Delegated Report

Full Planning Application

Application No:	20231053
Location:	56 Havisham Road, Gravesend, Kent, DA12 4UN
Description:	Extension and refurbishment of existing residential detached garage to provide ancillary residential accommodation.
Applicant:	Mr and Mrs B. Treleaven
Site Visit:	6 July 2023

Drawing number 1001 Rev A Project Number A23320.

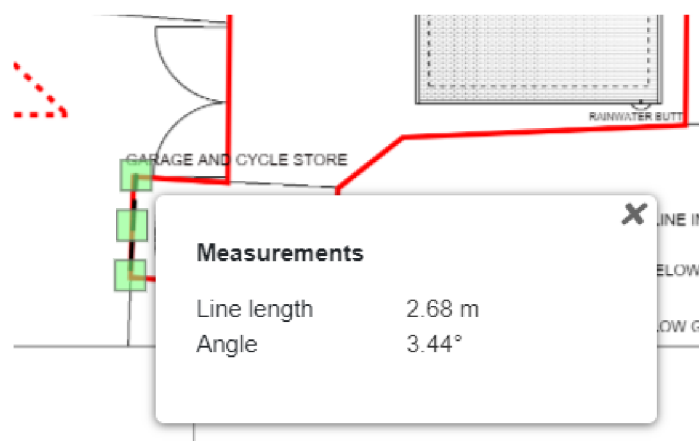
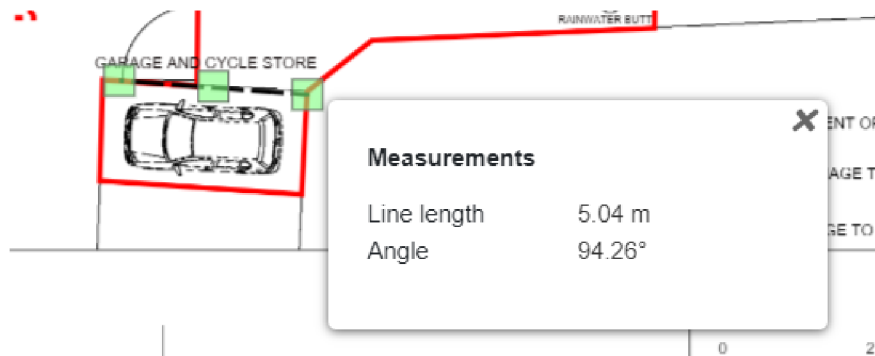
GBC Highways - This application requires very careful consideration as the car parking layout does not appear to conform to adopted guidance.

Kent County Council SPG4 determines car parking bay sizes, which are generally 2.5 metres wide by 5 metres deep, however the width is increased by 200mm when the parking space is adjacent to an enclosing boundary. Looking at the Google Street View image of November 2022, the parking area is confined by key clamp type handrail.

I measure the distance between handrails at some 5.01 metres so some 400mm below the requirement, so is only suitable for a single vehicle.

It is noted that the parking space at the rear does conform to guidance requirements, so the property benefits from two, but not three parking spaces identified and as such complies with the adopted guidance, providing the annex is ancillary to the occupation of the main dwelling.

However, as an extra bedroom is created a secure cycle parking space needs to be provided to comply with guidance.

However, Gravesham's Highways Officer has raised concerns with the size and viability of the parking spaces shown on the plans, highlighting that the railings on the frontage limit the width of the parking space available and that the garage is undersized. It is noted that the existing pre-fabricated garage would not be suitable for most modern vehicles, but the driveway, although tight, would be acceptable for the parking of no.2 vehicles in accordance with SPG 4.

Proposed Elevations

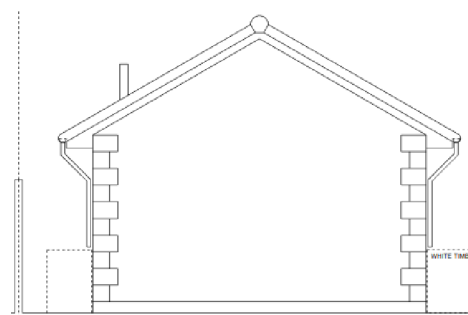
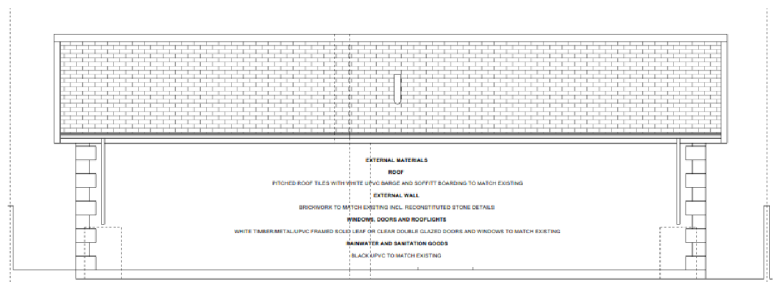
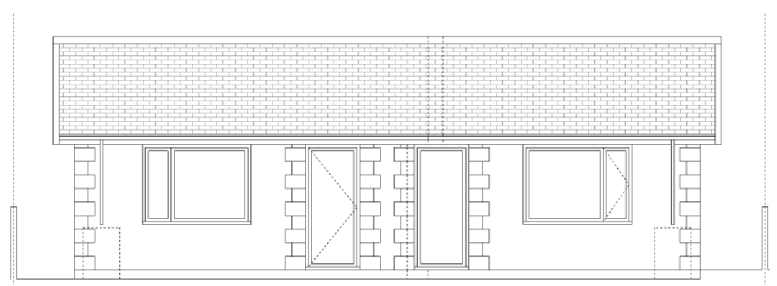
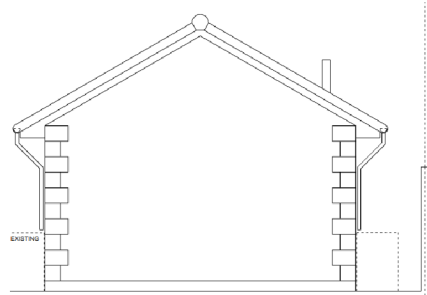
The extensions to the existing garage outbuilding would create a large structure in the garden, which occupies almost the full width of the garden. However, the extended building would not significantly exceed what could be constructed under permitted development, with only the eave height exceeding the 2.5m restriction. Therefore, as the scale and size of the extended building would be close to the parameters of the GPDO, there is no objection. Moreover, due to the building position in the rear garden, it would not be visible from public vantage point or impact on the character of the street scene.

In terms of the materials, the extension to the outbuilding would be constructed to match with facing brickwork and clay tiles, with uPVC windows and doors units. This continuity in material is considered to be acceptable.
